PROJECT NAME: STERLING HALL SCHOOL – PHASE 1 MASTER PLAN ADDITION

PROJECT No.: 00036-010-E-001

DATE: 2026-07-22

ADDENDUM No.: E01

scale: 1 : 75  
date: XX/XX/2X  
drawn: RLJG  
checked by: Checker  
project number: 00036.010.E001  
drawing number: E-701  
Revision: 8

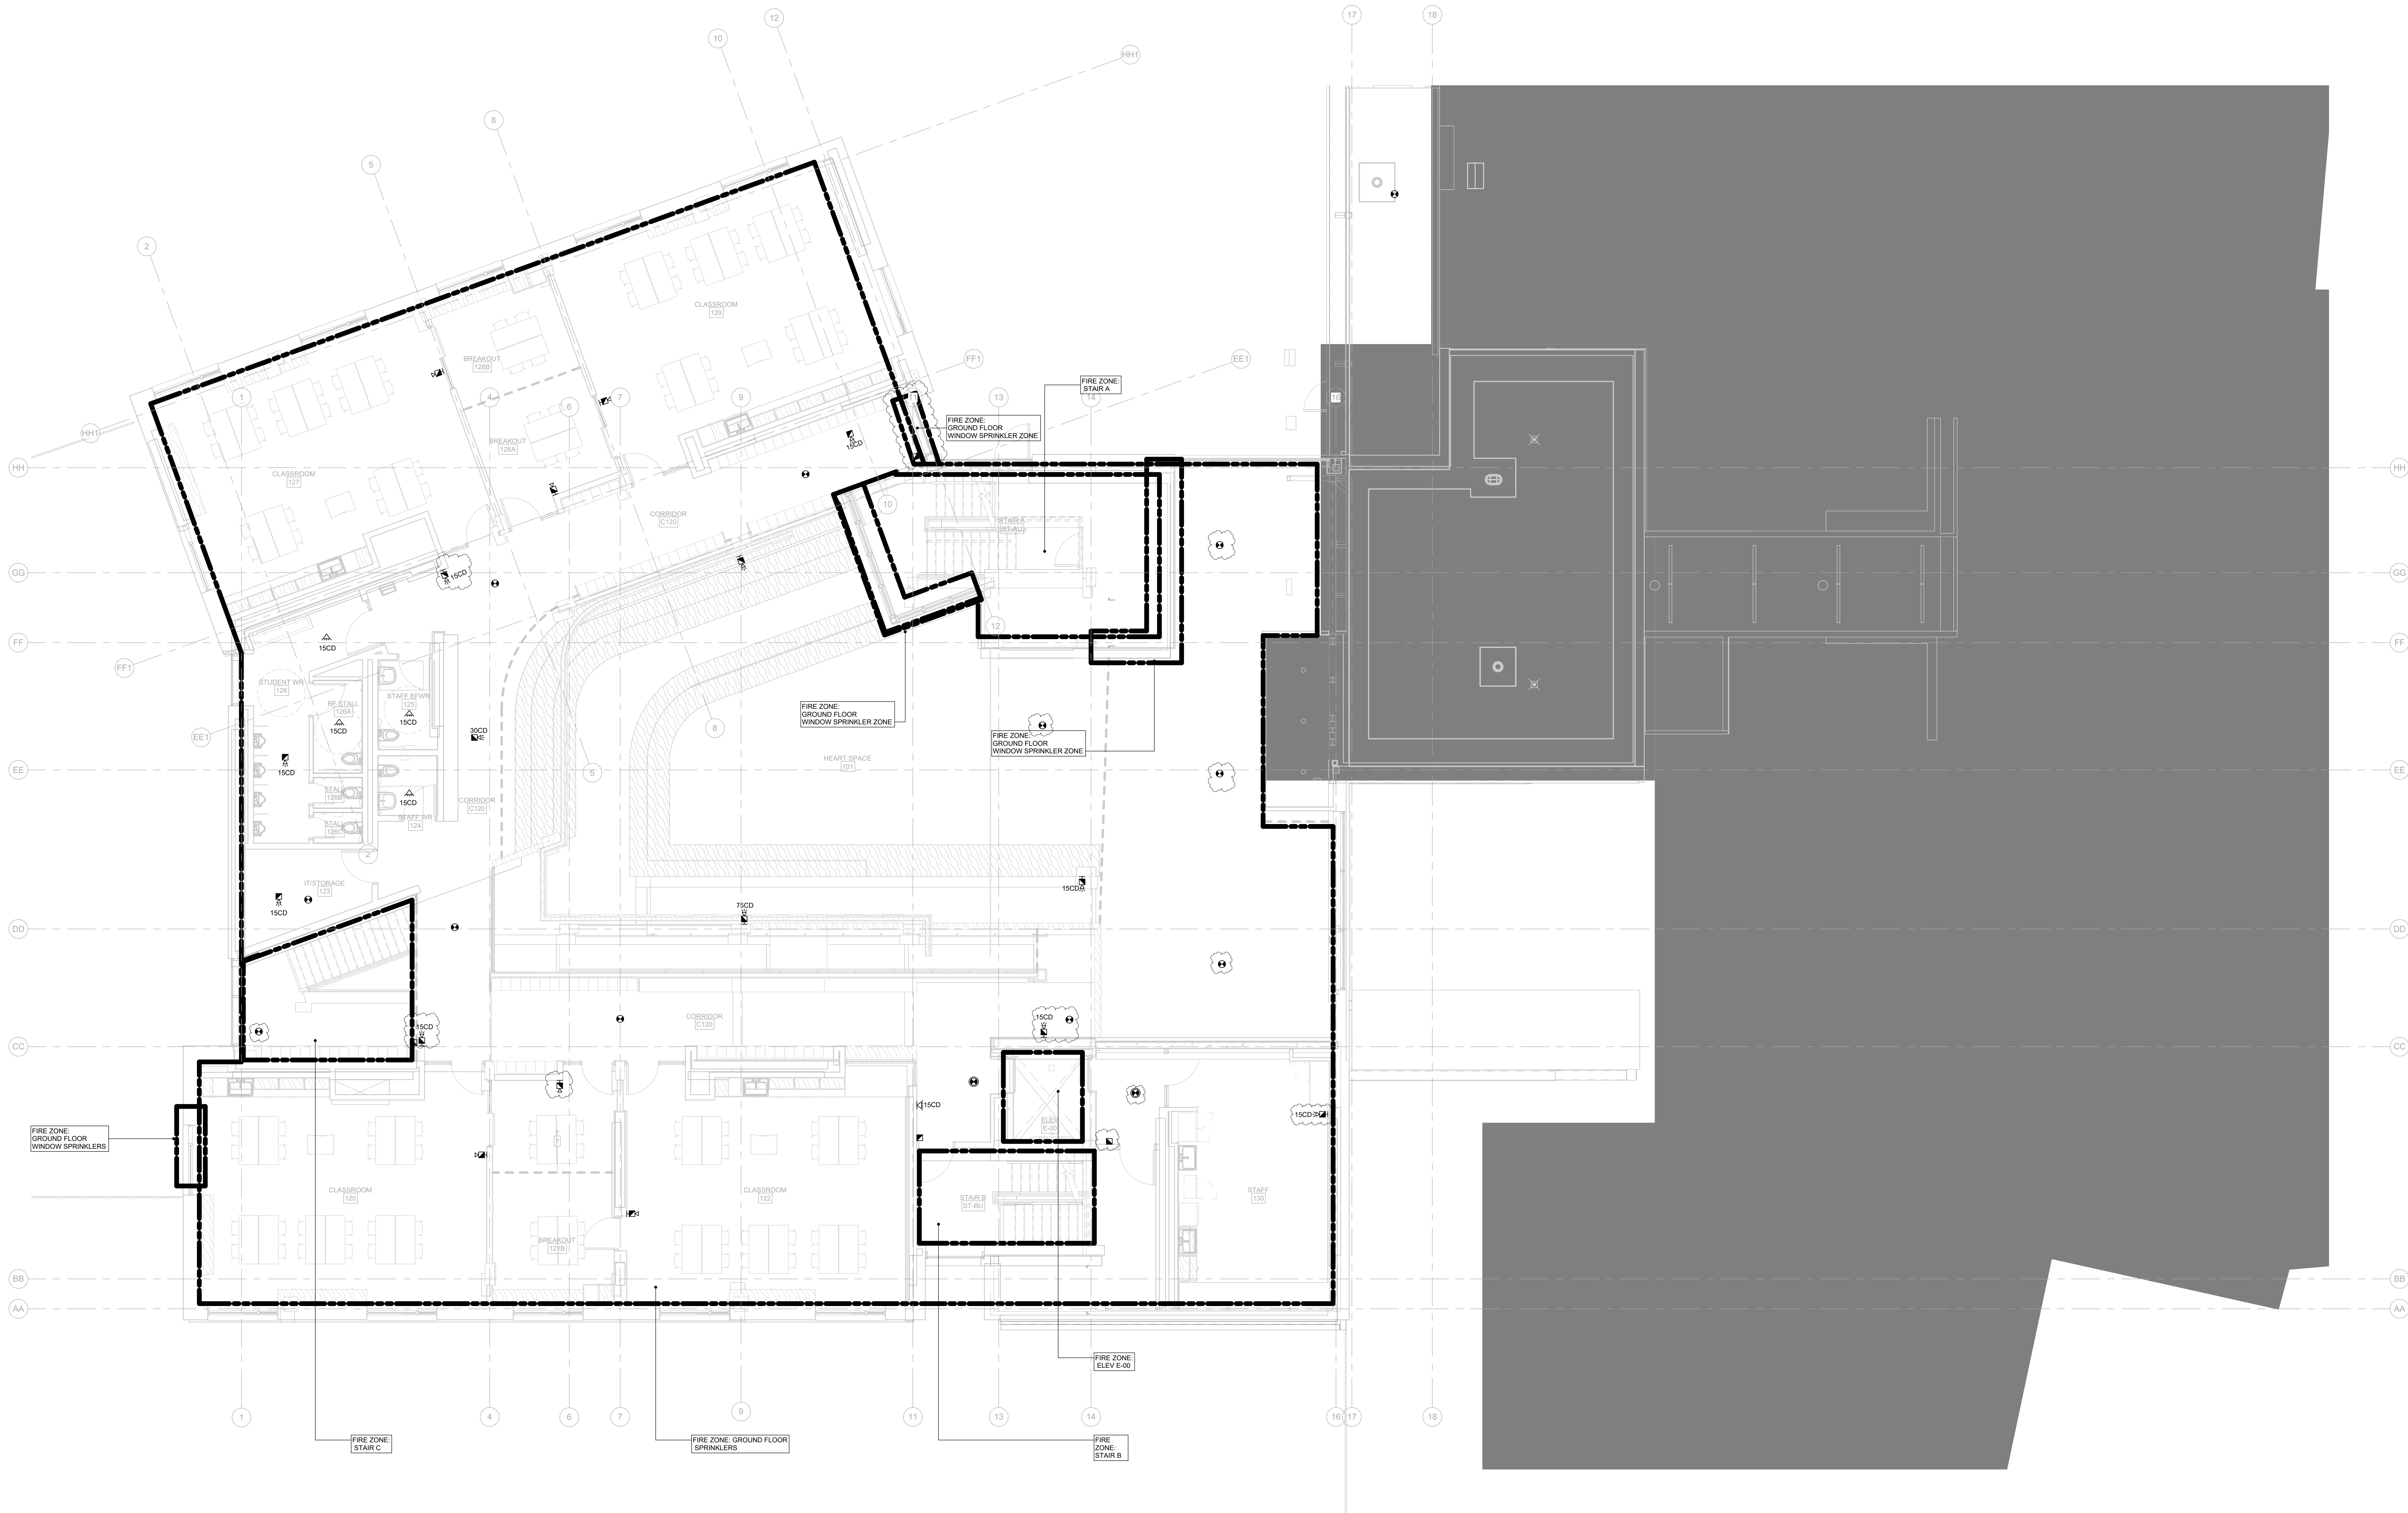
- 2.1.22 E-701: Revise fire alarm device layout.
- 2.1.23 E-701.5: Revise fire alarm device layout.
- 2.1.24 E-702: Revise fire alarm device layout.
- 2.1.25 E-801: Clarify demolition scope.

scale: 1 : 50  
date: XX/XX/2X  
drawn: RLJG  
checked by: Checker  
project number: 00036.010.E001  
drawing number: E-900  
Revision: 3

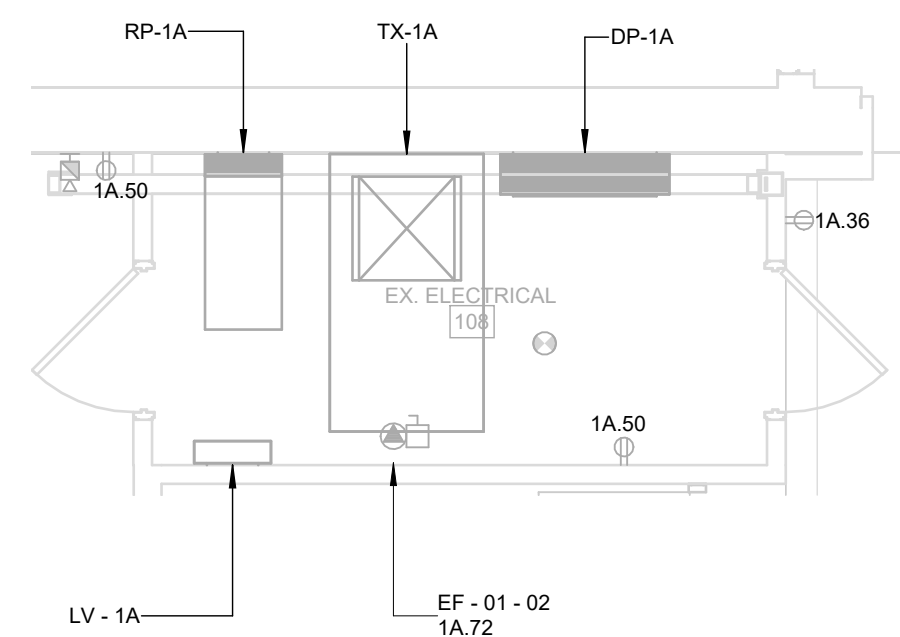
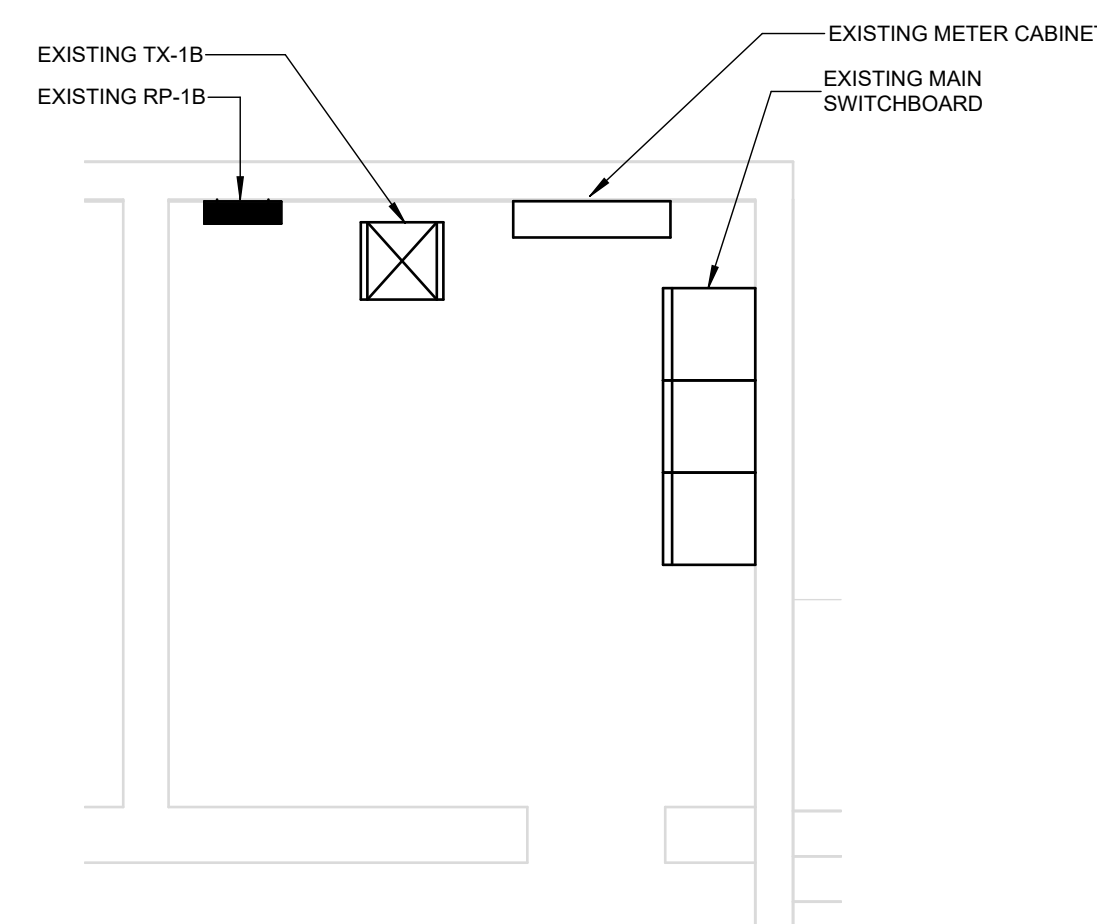
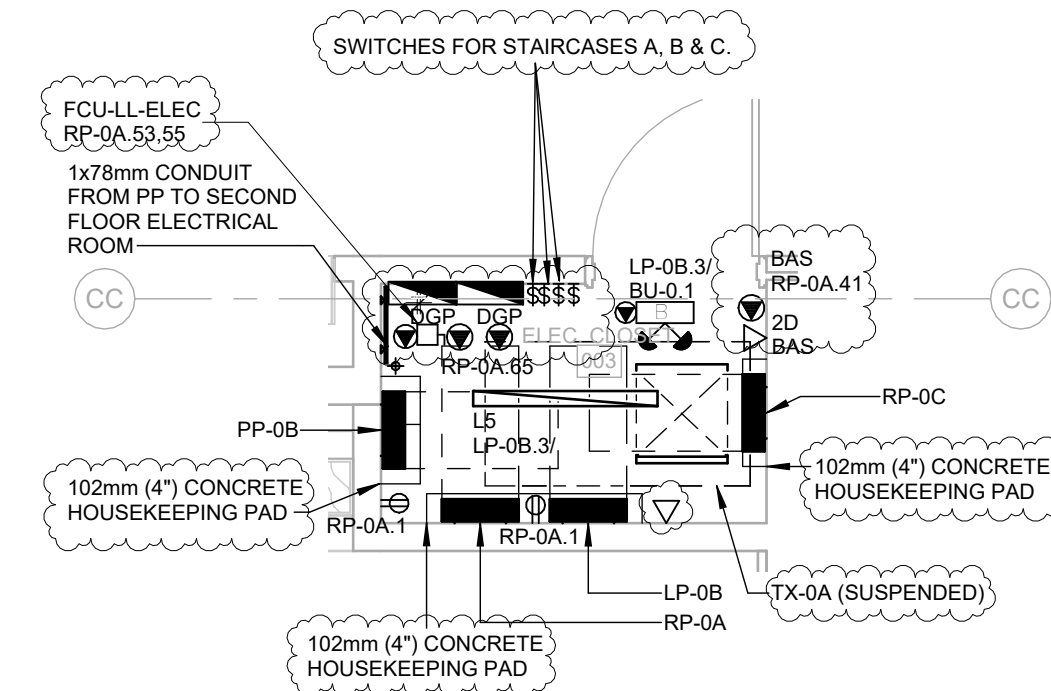
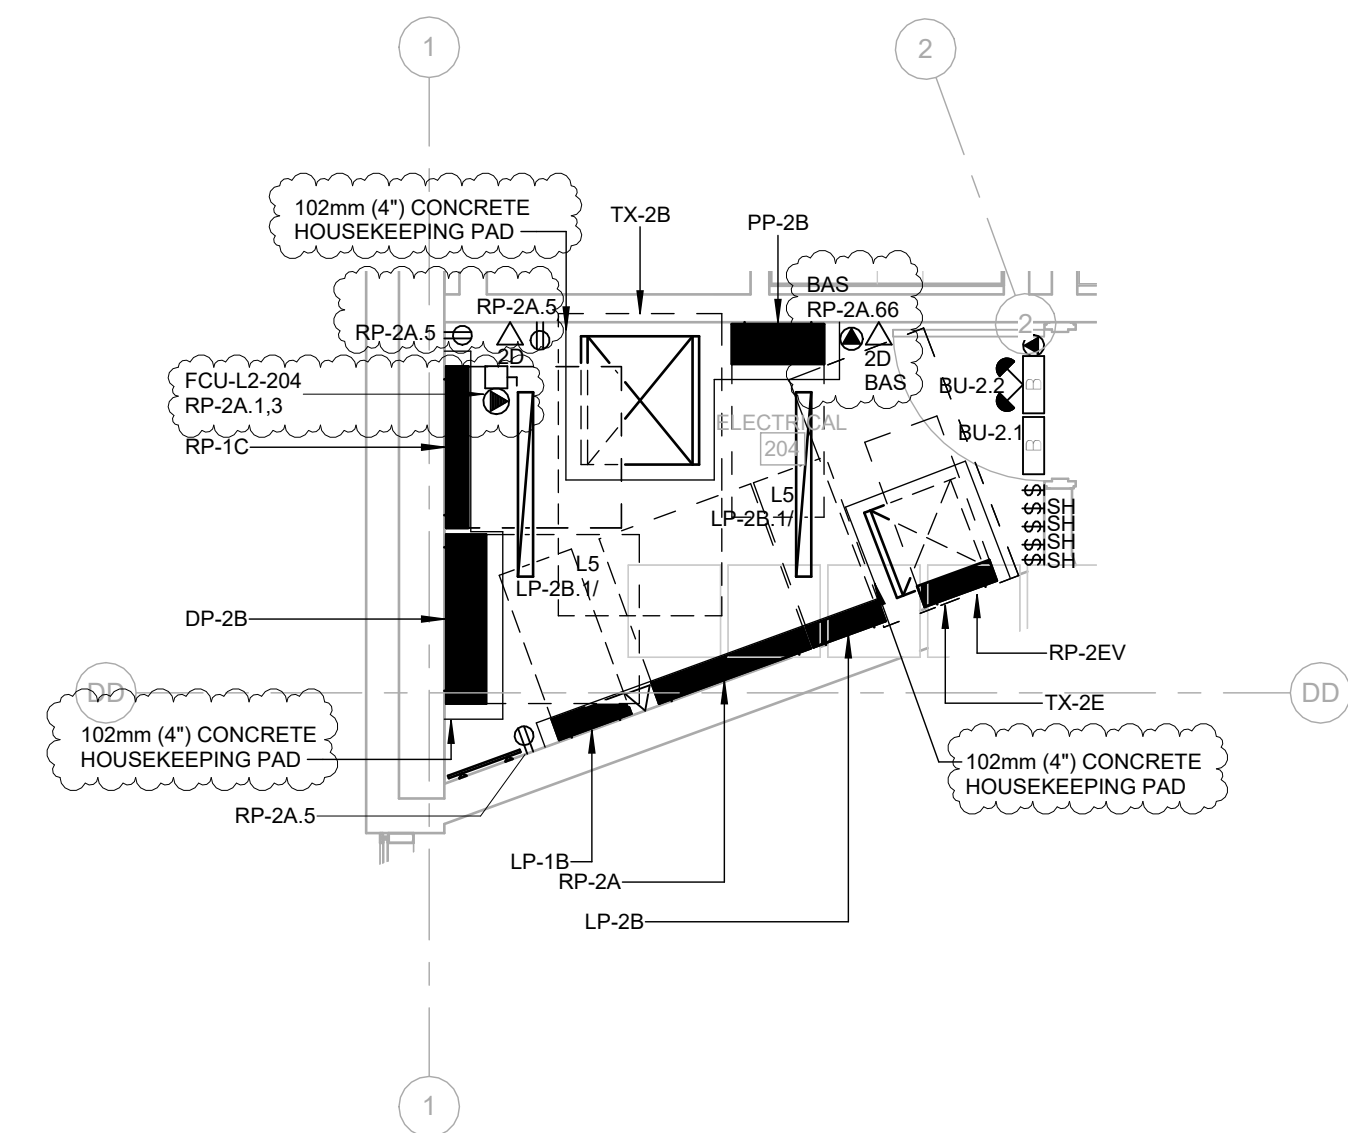
- 2.1.26 E-900: Add new detail. Add electrical and data outlet. Add circuits. Revise electrical room layouts.
- 2.1.27 E-901: Add circuits. Revise electrical room layouts.
